# CONSERVATION DEPARTMENT DETAILED AGENDA

Date: June 23, 2022

#### 1. 61 New Boston Road-Local NOI-Construction of a Single Family House

#### 2. 243 Big Alum Road- RDA-Site Improvements

| <b>PROPOSED SITE PLAN</b><br>RYAN & CHRISTINA LaFORTUNE<br>61 NEW BOSTON ROAD<br>STURBRIDGE MA<br>6 JUNE 2022 |   |

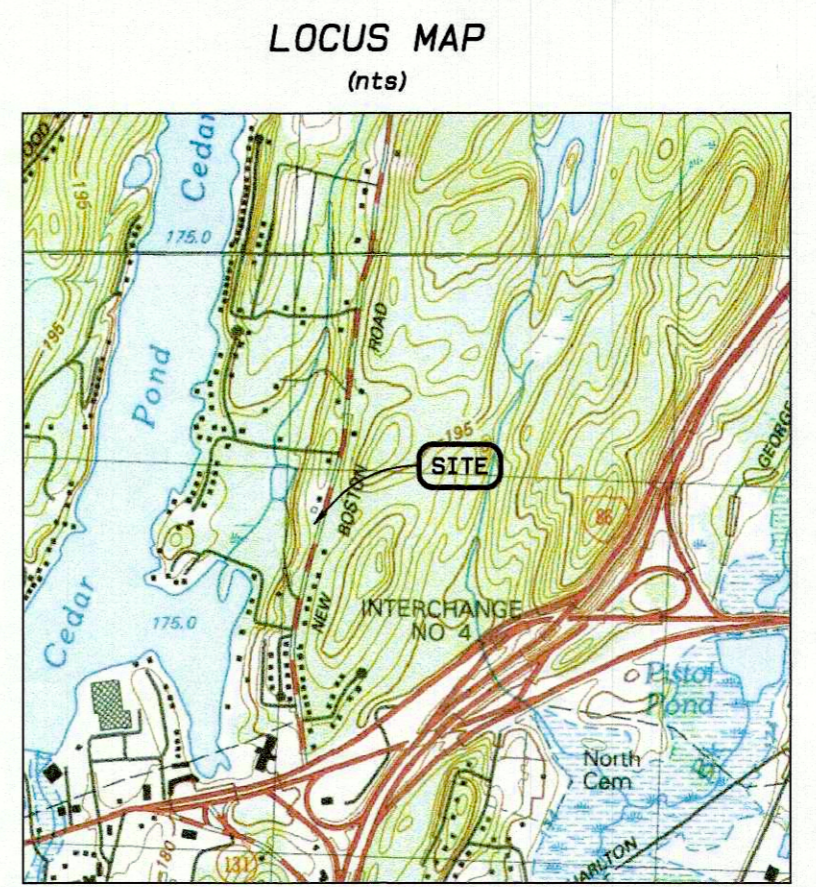
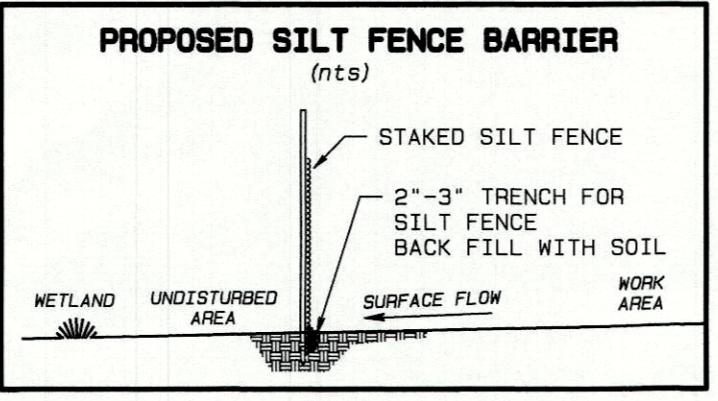
- Project includes erosion controls (silt fence only) at the LOW. Staff recommend that the ECs are located along the southern and northern property lines versus on adjacent properties. ECs should be set off property lines. That will also assist with prevention of materials from migrating to the low point/cart road area which heads to the wetland. A straw wattle should be installed in addition to the silt fence.

- Road is a scenic road. Tree removal in the road ROW would require Planning Board approval.
  - DPW noted that there could be concerns with nearby drainage for a new development here. This should be discussed with the DPW. The ECs should be installed to not allow drainage into the work area during work.

- Standard OOC conditions.
  - Sedimentation controls shall be installed as mentioned above and maintained during work.
  - Require a surety bond or deposit of money during work to ensure conditions are met. Funds to be returned or bond to be released upon issuance of a Certificate of Compliance. \$5,000 for new single family house development has been previously required. To be released upon issuance of a Certificate of Compliance.

# 243 Big Alum Road

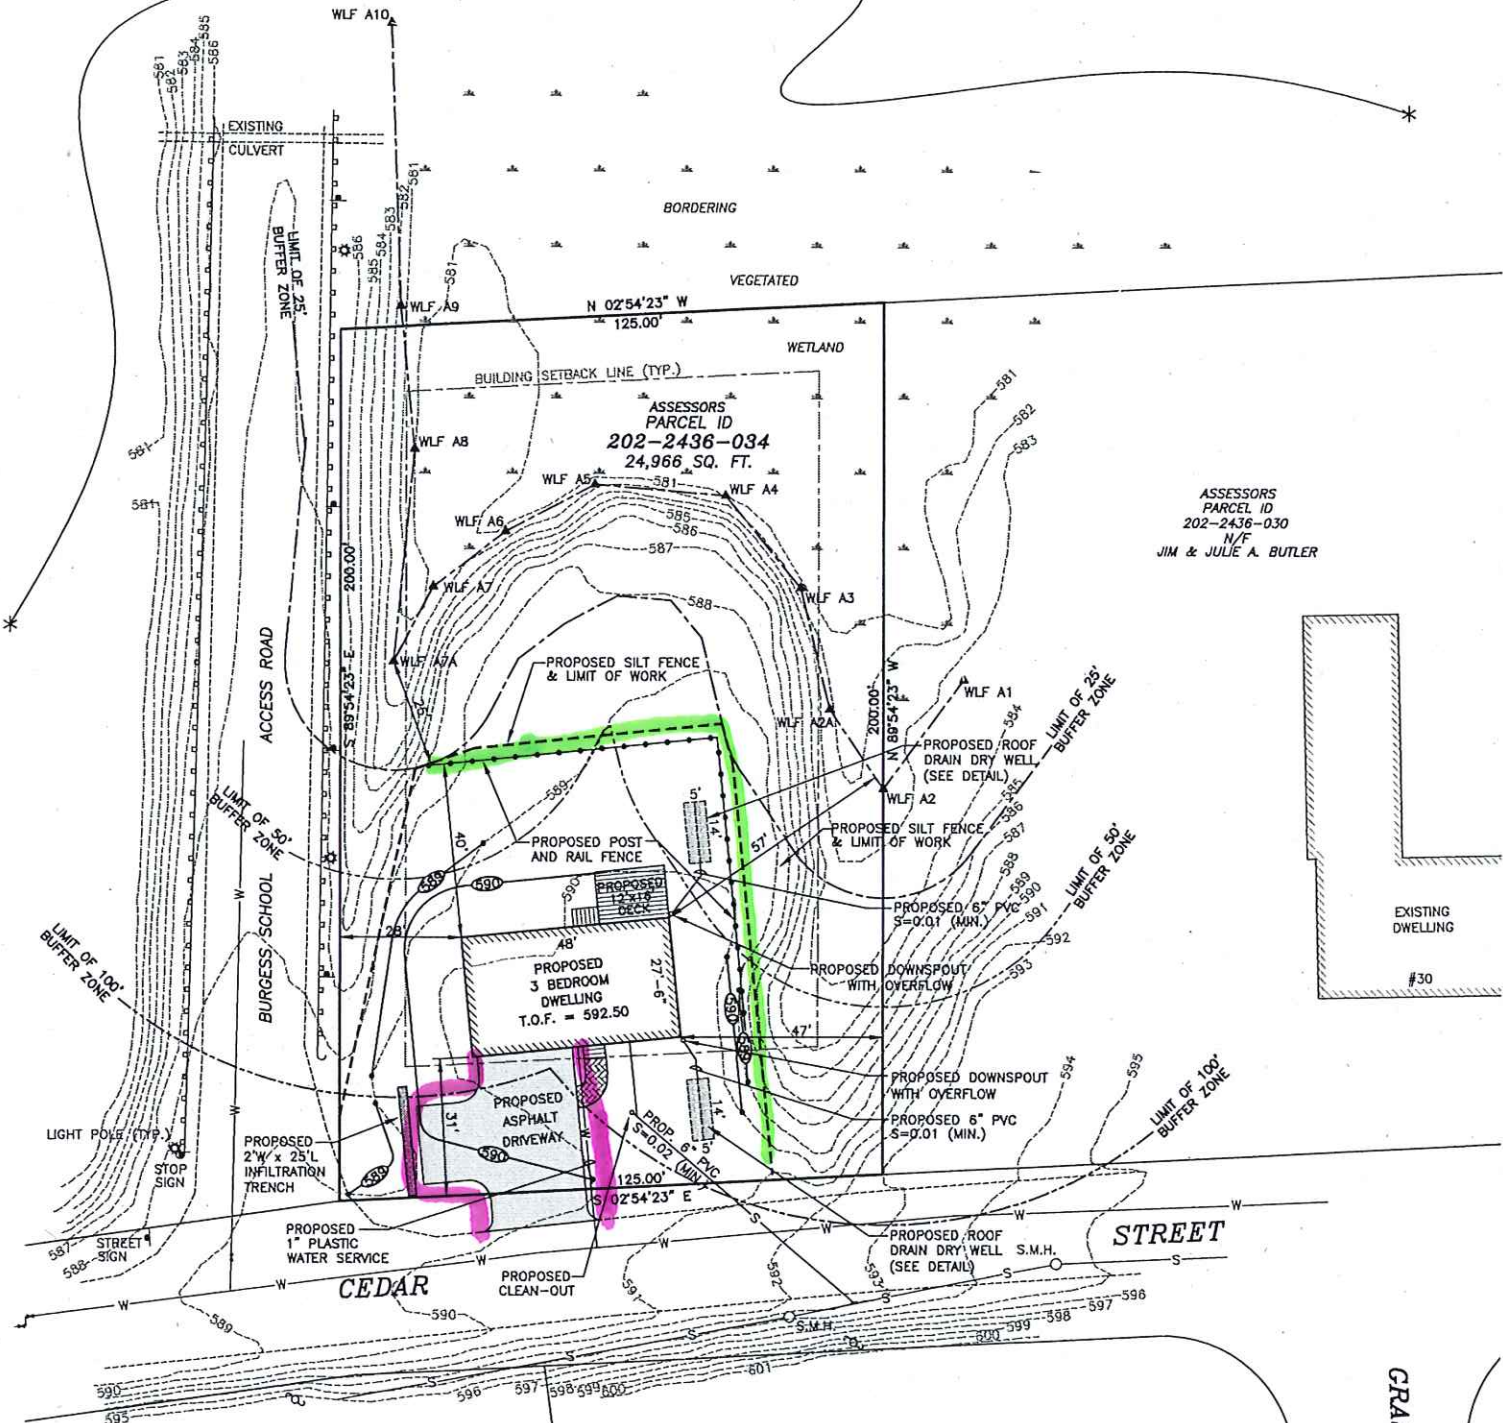
- Also proposing to clean out an unmaintained road swale along Big Alum Road. This is a private road and the swale is on his land. Details pertaining to how it will be done and where materials are to be deposited would be useful. It's important to make sure that inadvertent impacts don't occur downstream as this discharges to wetlands.

- Additional info on location of the fence appears necessary in order to evaluate.
- DPW noted some of Big Alum Rd is town owned. Will need to coordinate w/ DPW ensure that work is just on his land and go over project with them. May have recommendations.

- Staff have no overall concerns with the project but additional detail should be provided on the items noted above to evaluate as part of this decision. Staff spoke to owner and additional info to be provided. Fence to be removed from application as survey work has been delayed. Will file for fence at a later time.

- Minimal vegetation clearing to be completed for swale clean out.
  - Swale work not to be completed during inclement weather. All excavated material to be immediately loaded and removed from BZ.

- Work with DPW prior to swale work.
  - Standard pre-work and sign of conditions.
